S E R V I C E N O T E

6653A 500W General Purpose Power Supply

Bridge Rectifier Failure

6653A-07 Serial Number: US000000000 / US36401180 6553A-04 Serial Number: US000000000 / US36340337

Figure 2a. Diode Assembly

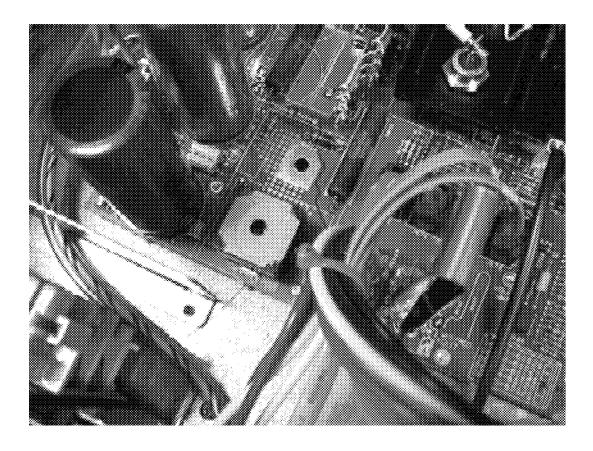
3. With a pair of wire cutters, snip the leads of the bridge on the main board. (See Figure 2a and 2b.) It is not necessary to remove the remaining leads from the board. Please inspect the board to check for any shorts.

To remedy this situation, a diode heat sink assembly will replace the diode bridge that continues to fail. The procedure for replacing these units can be found in the paragraphs below.

Figure 2b. Standoff

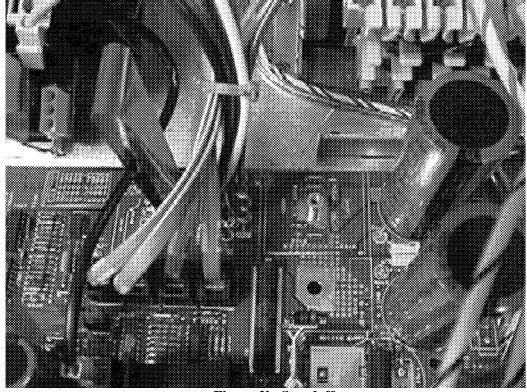
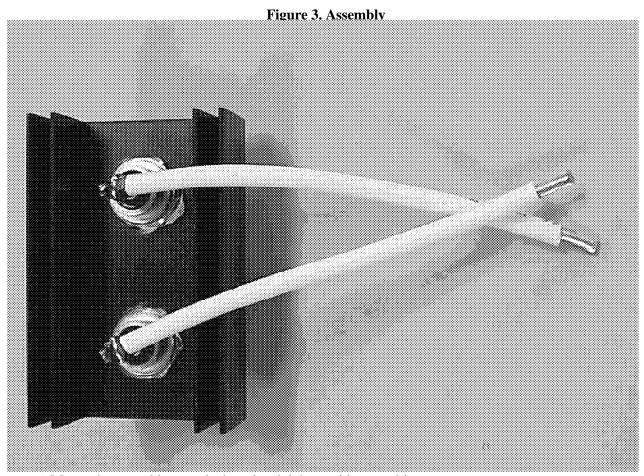
4. Turn the board over to remove the standoff located under the bridge rectifier. Crimp standoff towards middle for easy removal. This will decrease damage to the inner plating of the standoff hole.

5. Remove solder from holes E405 and E406. Insert and solder the wires seen in Figure 3 into these holes.
